PROJECT: Summerlin West V25 - Scurry Bend Drive Improvements

CITY OF LAS VEGAS INTER-OFFICE MEMORANDUM		DATE: June 3, 2021
TO: Land Development Services Department of Building & Safety		FROM: Albert Sung, P.E. Flood Control Project Engineer Department of Public Works
SUBJECT:	Drainage Study for:	COPIES TO:
Summerlin West V25 - Scurry Bend Drive Improvements (from Sunset Run Dr. to Lake Mead Blvd.)		Atkins
Cross Streets:	Scurry Bend Drive. & Lake Mead Boulevard	Howard Hughes Company, LLC
File Number:	F:\Depot\DSMemos\DS5427C.doc	Bart Anderson, P.E., DevCo
Parcel Number:	137-15-801-002 & more	
Zoning Action:	N/A	
FEMA Flood Zone	YES NO X	
Proposed Storm Drain	YES X NO

Addendum #2

**RE: ADDENDUM #2 TECHNICAL DRAINAGE STUDY FOR SUMMERLIN WEST VILLAGE 25
SCURRY BEND DRIVE – SUNSET RUN DRIVE TO LAKE MEAD BOULEVARD**

DESIGNED BY: B. MOCHTAK
DRAWN BY: K. HENDRY
CHECKED BY: N. BARCOS
DATE: MAY, 2021
DRAWING NO. 24/42
JOB NO. 100069098

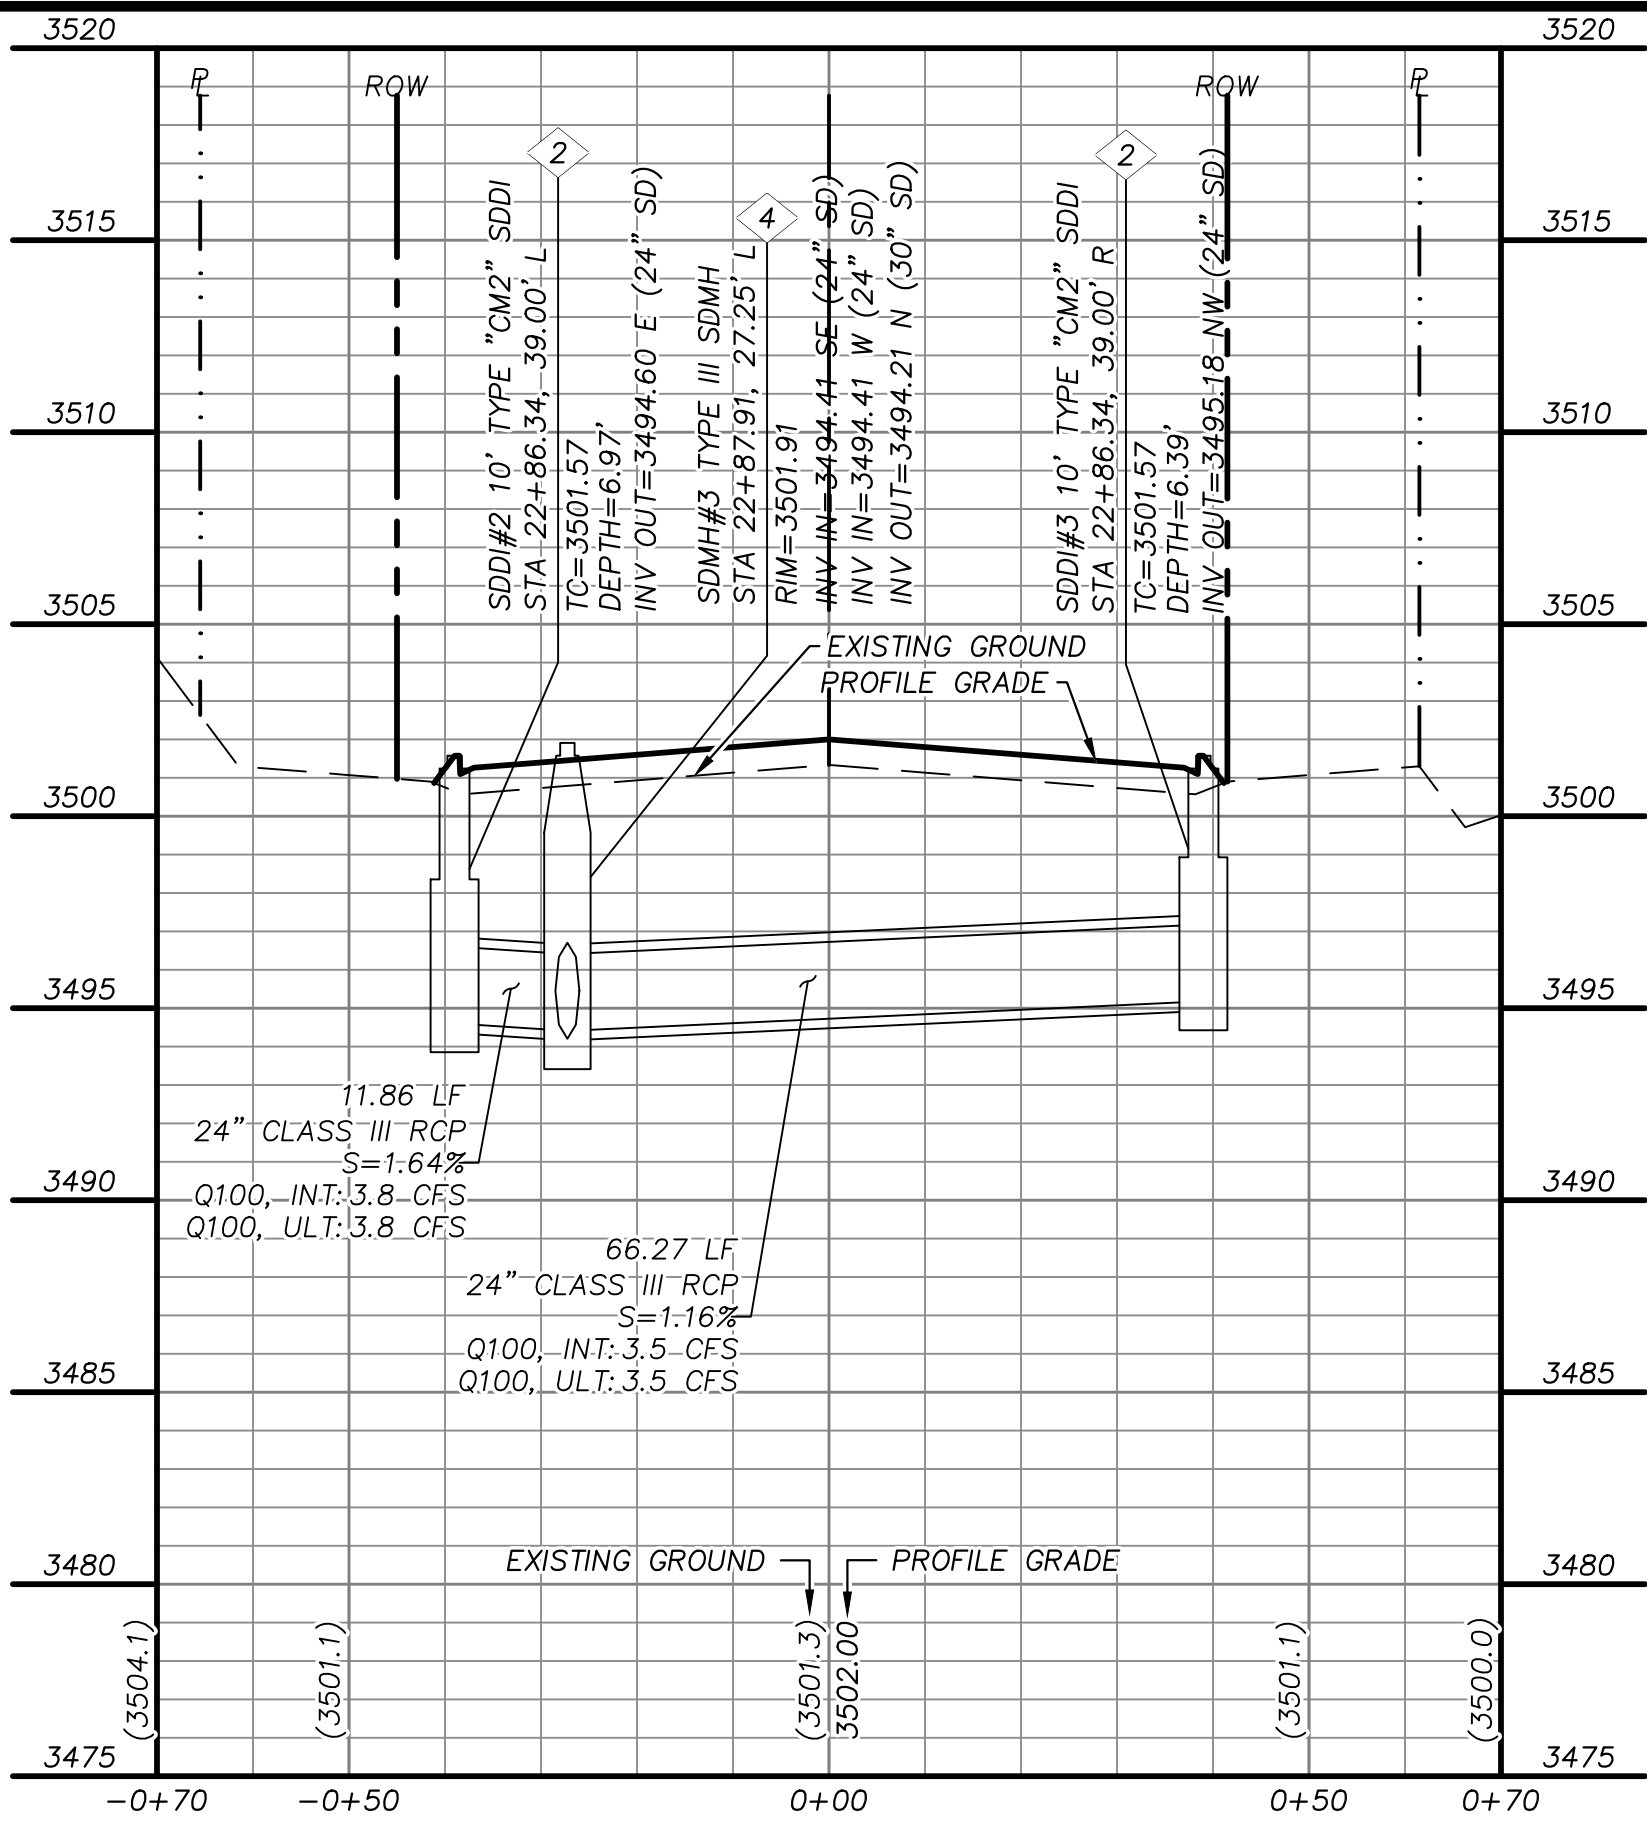
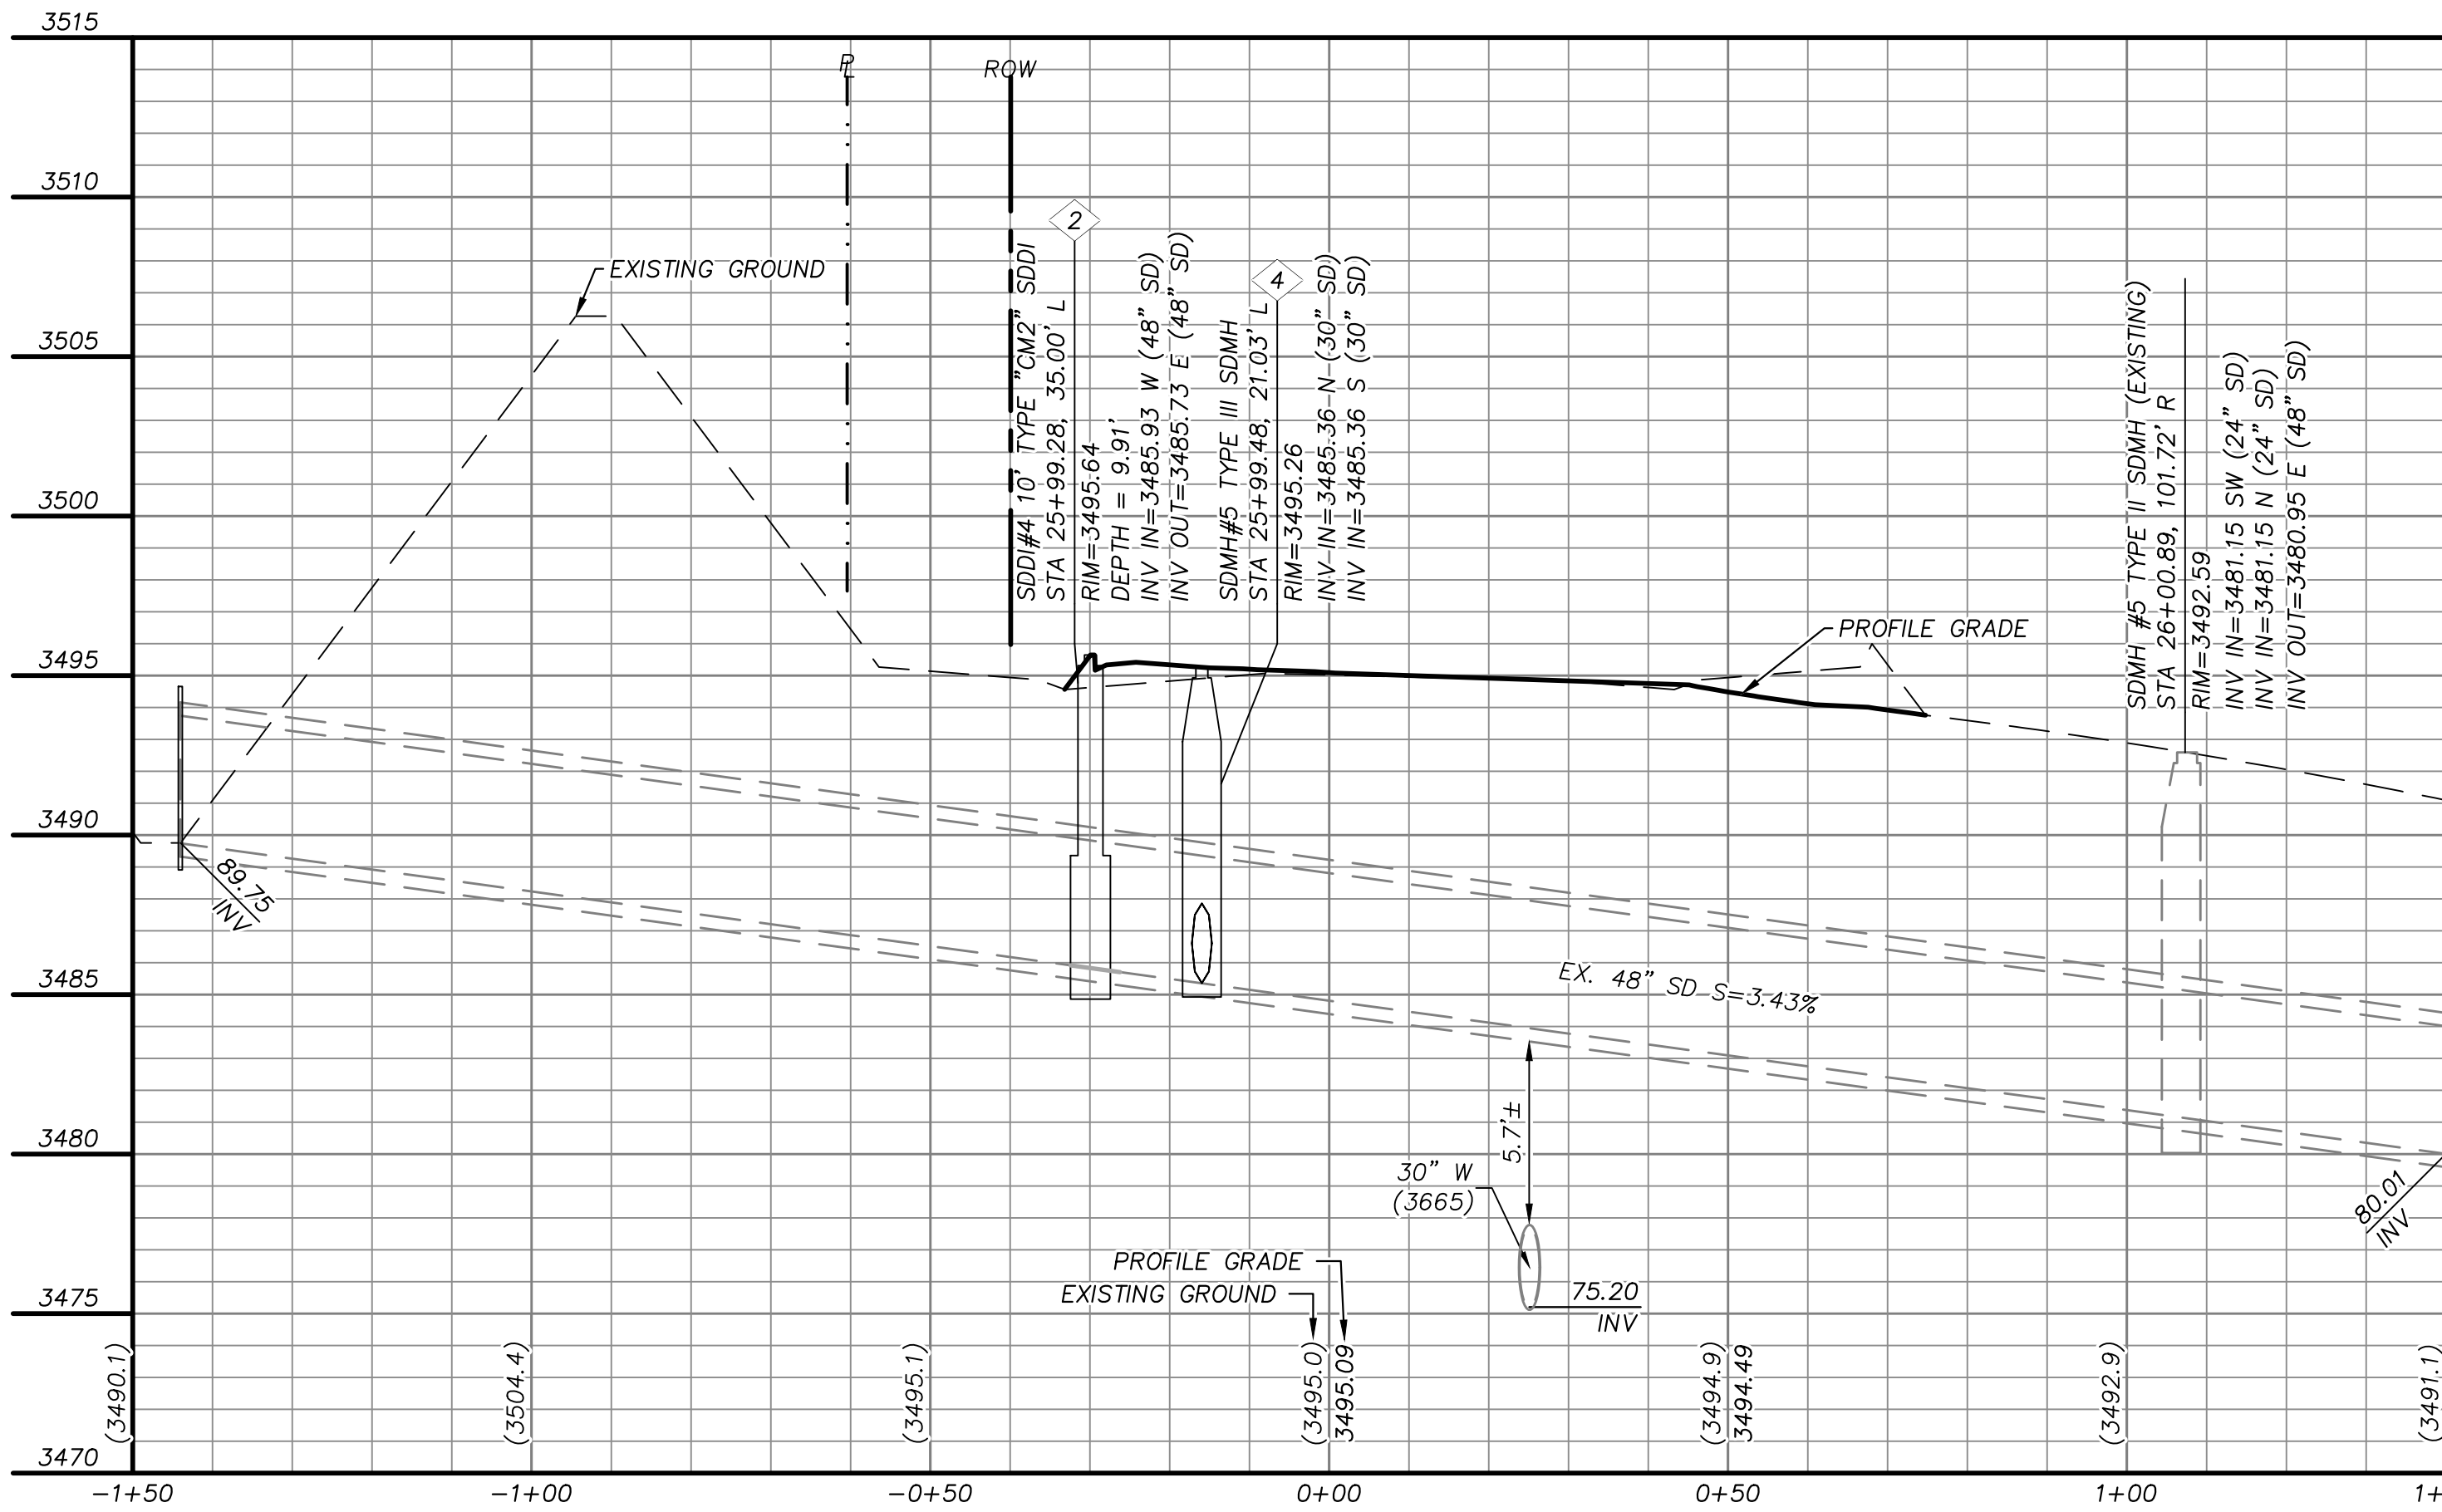
Comment #6: Previous Comment #18: *Indicate the length and depth of the inlets on all pertinent plans. Any inlets deeper than 10' require City Building & Safety Department review and approval of the structural design and calculations.*

It is still not clear what's the depth of SDDI #4.

Comment response: The drop inlet labels on the Sheet 24: Storm Drain Lateral Profiles have been updated with that specify the inlet length and depth.
